Report of Staff Recommendation

File No.: 9-B-22-TOB

Request: BUILDING PERMIT

Proposed Land Use: Harper Auto Collision Center

Concept Site Plan

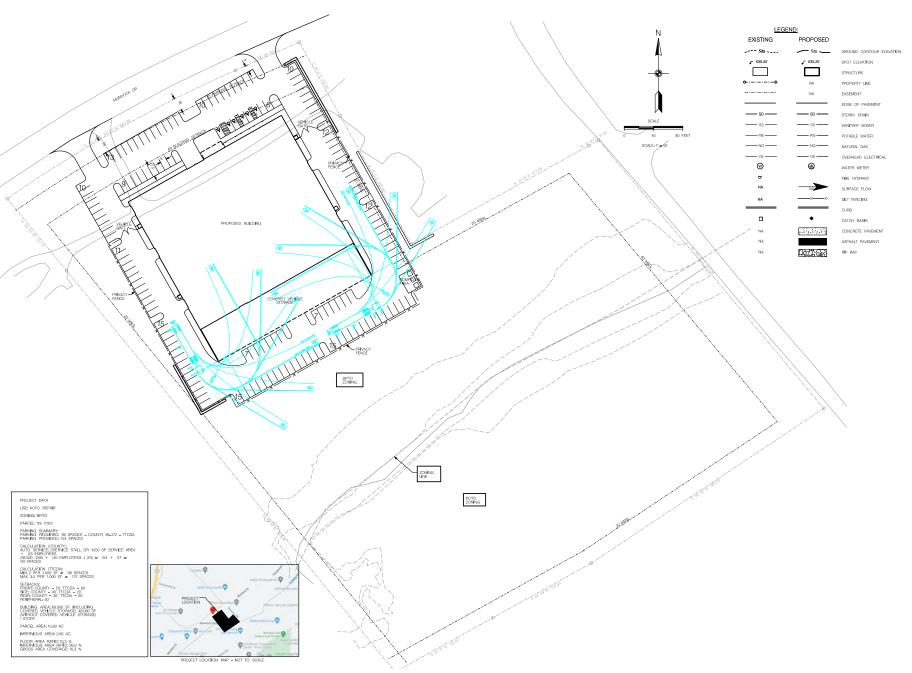
- 3) Changes consist of the following:
 - a) Moving the dumpster location so that it is farther from the street. It is now proposed in the fenced rear parking area.
 - b) Changing the front (north) facade material from metal panels to painted, split-face smooth CMU block.
 - c) Changing the overhang at the main customer entry on the north facade from metal to EIFS.
 - d) Moving the metal gate and fencing back roughly 30 feet further into the site.
 - e) The landscaping plan has been revised accordingly, with the dumpster screening removed

- since it is no longer near the street and is not readily visible from the street. The rest of the landscaping plan remains unchanged.
- f) The parking lot configuration was modified slightly due to the relocation of the fence. The original plans proposed 142 parking spaces. However, in reviewing the function of those spaces, staff has determined they are more for vehicle storage and would not be used for customer or employee parking. Therefore, they can be counted as vehicular storage spaces. The applicant now needs a waiver to reduce the minimum number of parking spaces from 77 to 60 so it is more closely aligned with the needs of the business. Staff supports this waiver since it precludes unnecessary parking spaces located on the site, which would increase the amount of impervious surface.

Staff recommends approval of this request for a Certificate of Appropriateness for a building permit, subject to six conditions:

- 1) Connection to sanitary sewer and meeting any other relevant requirements of the utility provider.
- 2) Installation of all landscaping as shown on the development plan within six months of the issuance of an occupancy permit, or posting a bond with the Knox County Department of Engineering and Public Works to guarantee such installation.

- 3) Installation of all sidewalks as identified on the site plans. Sidewalks connecting those along the right-of-way with those at the church entry may be required by the Knox County Engineering Department during the permitting review stage and would be coordinated at that time. Knox County Engineering reserves the right to waive the sidewalks due to the steep topography if found to be unreasonable to install.

L100

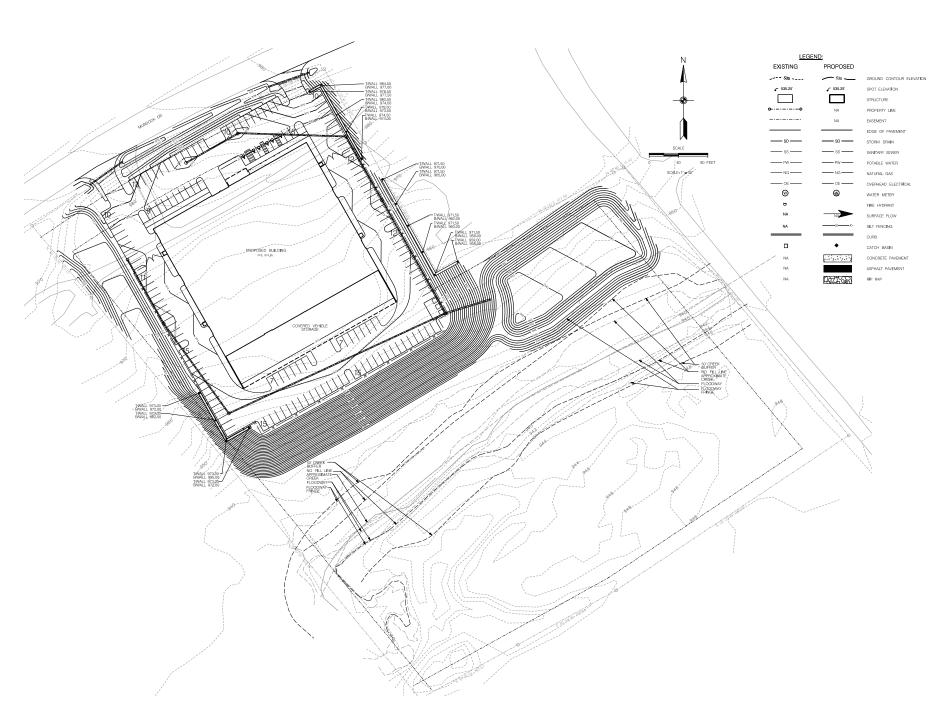
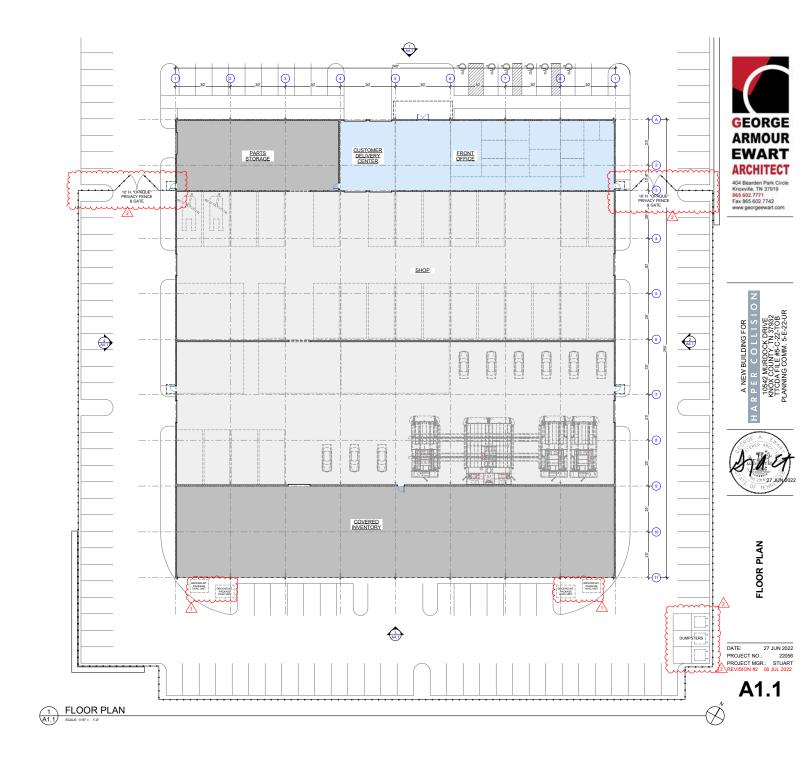
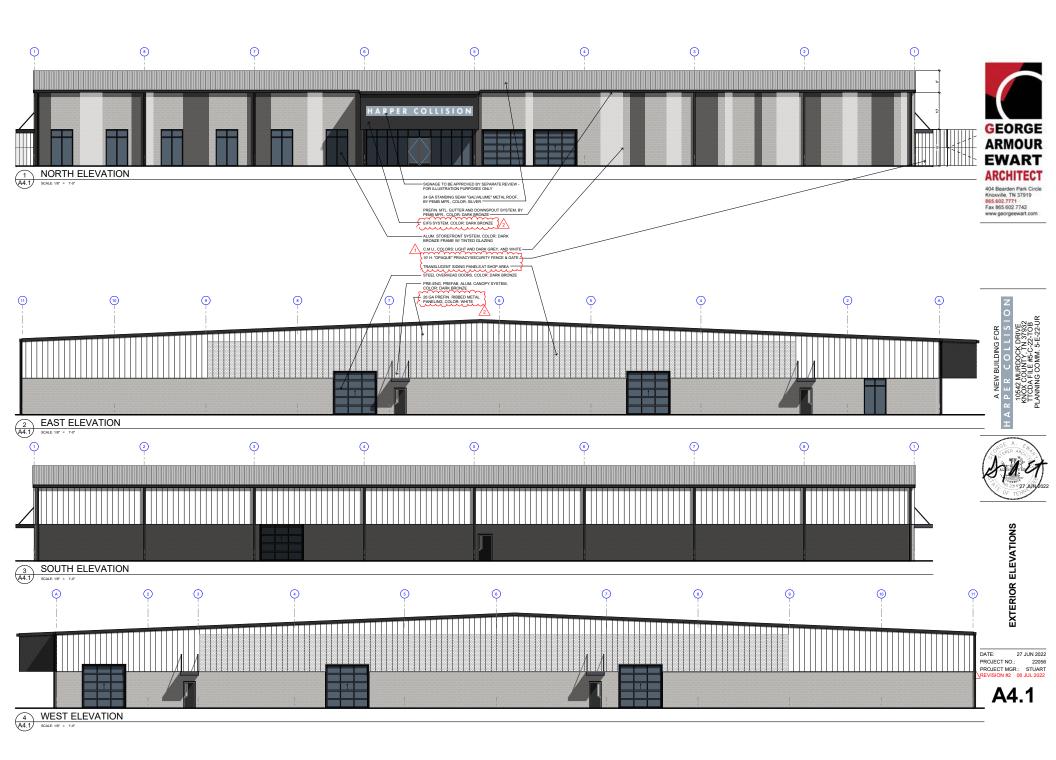
Updated Site Plan, revised tree

locations and shrub count
